COMMUNICATION from the City Plan and Zoning Commission advising that at a public hearing held December 7, 2006, the members voted 10-0 in support of a motion to **APPROVE** the request from Nelson Development 13, LLC (owner) represented by Jake Christiansen (officer), for approval of a preliminary subdivision plat for "South of Grand Estates" located at 361 31<sup>st</sup> Street, to create four lots for single-family residential development served by a private access drive and public sewer extension subject to the following:

RE: Preliminary Plat, South of Grand Estates  
13-071.28

# SOUTH OF GRAND ESTATES - PRELIMINARY PLAT

**SOUTH OF GRAND ESTATES**  
**PRELIMINARY PLAT**

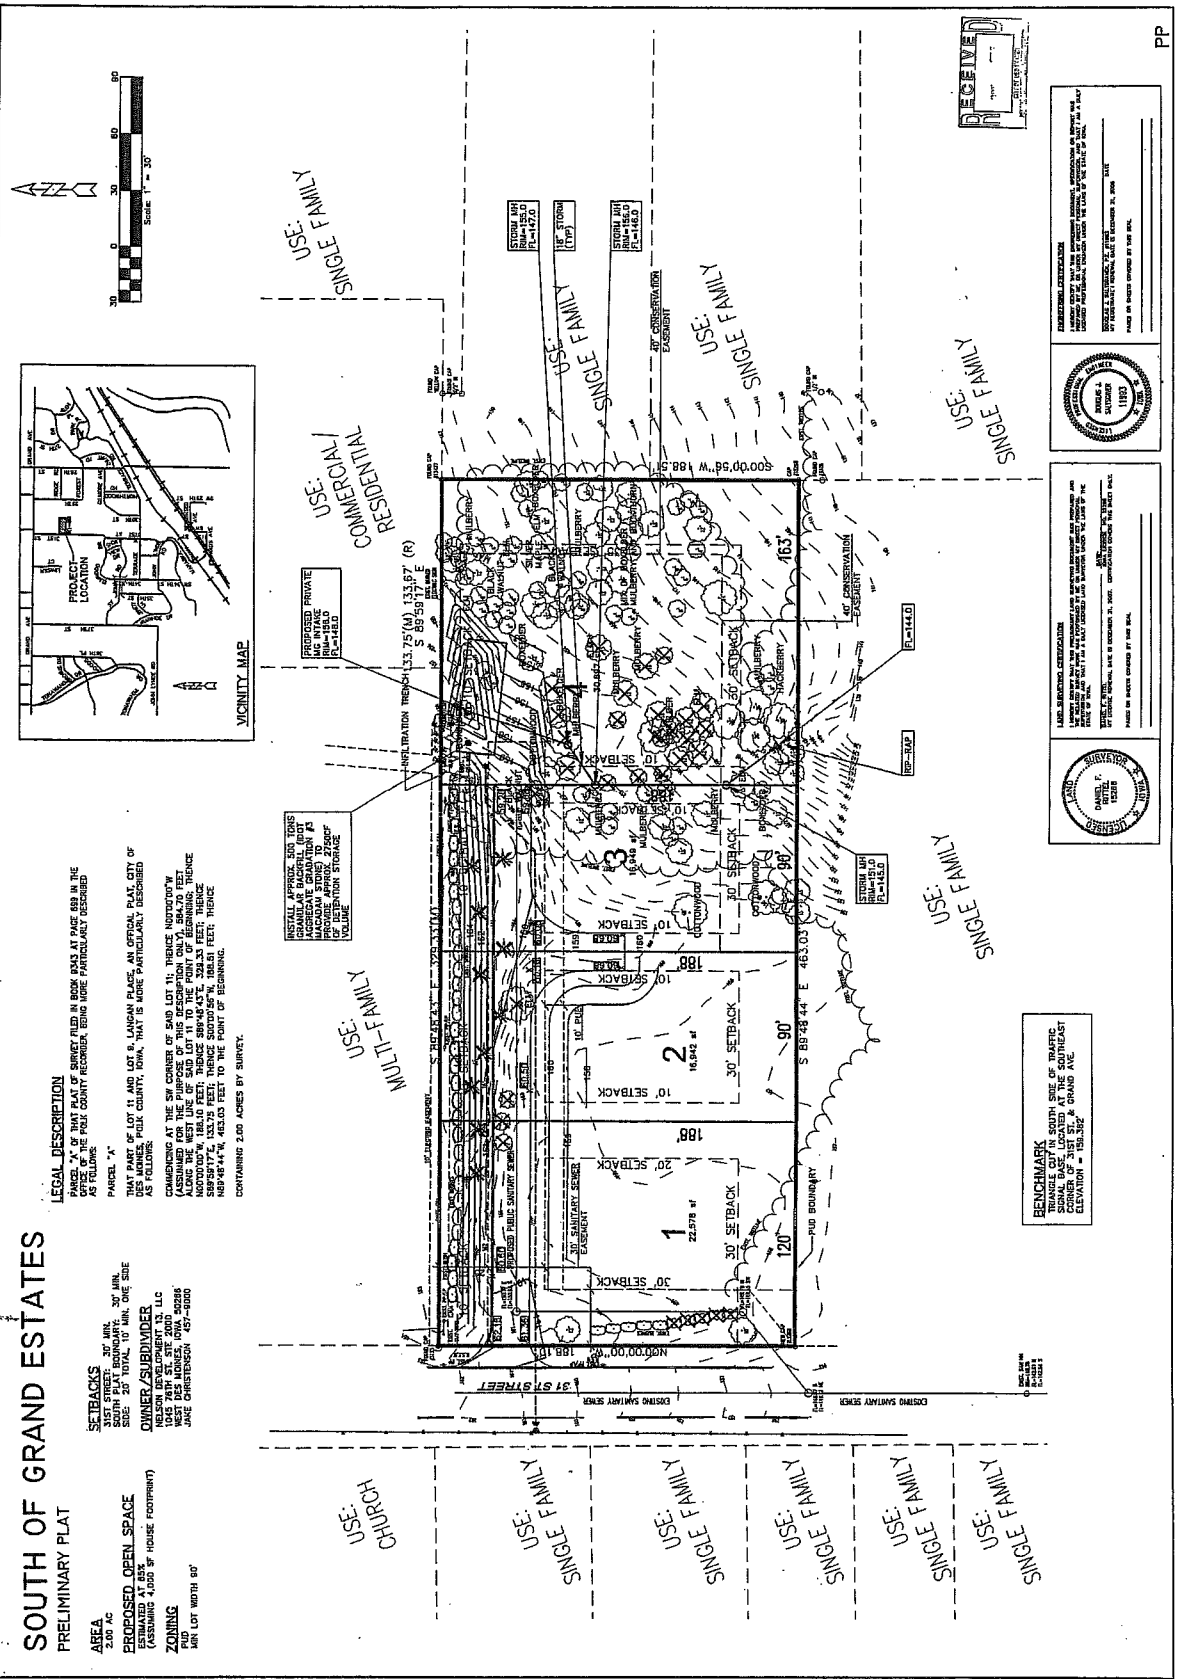
1. Legal Description—Identify the adjoining properties to the north, east and south.
2. Surveyor/Engineer Certification—Sign and date the certification statements. The drainage detention calculations require an Engineer's signature.

3. Surface Features—Show details of how the surface drainage will be directed from the east end of the drive to the detention basin.
4. Subsurface Features—The proposed north-south sanitary sewer in lot 1 has a grade of less than 0.3% according to the proposed flow line elevations and distance between manholes scaled from the plat. Provide certified calculations that minimum cleansing velocities can be achieved.  
Indicate how footing drains from the proposed houses will be handled.

5. Drainage Report and Recommendations—Show calculations for the times of concentration used in determining the rainfall intensities for Q2 and Q100 in the calculations for the allowable release rate.

Show the flow paths, slopes and roughness coefficient.

If the area of the portion of the subdivision to be detained is 0.5 acres and the composite runoff coefficient is 0.68, isn't the  $C \times A$  value on the detention volume twice what it should be?

We are not able to verify the value of 40% for the voids in the granular backfill. Please provide a source. Show a detail of the 500 tons of granular backfill to be placed, as to width, length and depth. Assuming the 20' X 60' rectangle on the plat is the extent of the backfill, our calculations show the backfill would have to be more than 5.5 feet deep to provide 6755 cubic feet of available space.

In sizing the outlet orifice, how was the 4 feet of head arrived at? Typically, it is from the center of the orifice to the elevation at which the required detention storage is achieved.

Provide calculations for the flow velocity at the outlet. If erodible velocities are indicated, provide a means to spread the flow and dissipate energy.

7. The dedicated fire apparatus turn-around area shall be marked with permanent NO PARKING—FIRE LANE signs. Signs shall have a minimum dimension of 12 inches wide by 18 inches high and red letters on a white reflective background. Show the location of the fire lane signs on the site plan.

8. The approved PUD Concept Plan must be submitted, signed and dated and on reproducible mylar before the preliminary plat can be approved.
9. A plat legend was left off of this submittal.
10. Place the following notes on the plat (condition of PUD Plan approval):

Homes on Parcels 2, 3, & 4 must have a primary entrance oriented toward the private drive, and the home on parcel 1 must have a primary entrance oriented toward either 31<sup>st</sup> Street or the private drive.

11. Mid-American Energy is requesting a 15' P.U.E. to accommodate both underground gas and electric lines.
12. Show the required conceptual street plantings in the parkway of 31<sup>st</sup> Street at one tree per 40 lineal feet.
13. Replacement of all removed evergreen plantings on a one-for-one basis is required. Show the location, type and planting size of the evergreens. The shrub line indicated for removal for the sanitary sewer installation will need to be replaced on a one-for-one basis as well.
14. Are all trees that will realistically be impacted by site grading shown as "removed" on the plat? There appears to be additional trees not marked for removal that are in the middle of proposed grading work.
15. Place the tree protection notes on the plat as stated in Condition #3 of the enclosed council roll call for approval of the PUD Plan.
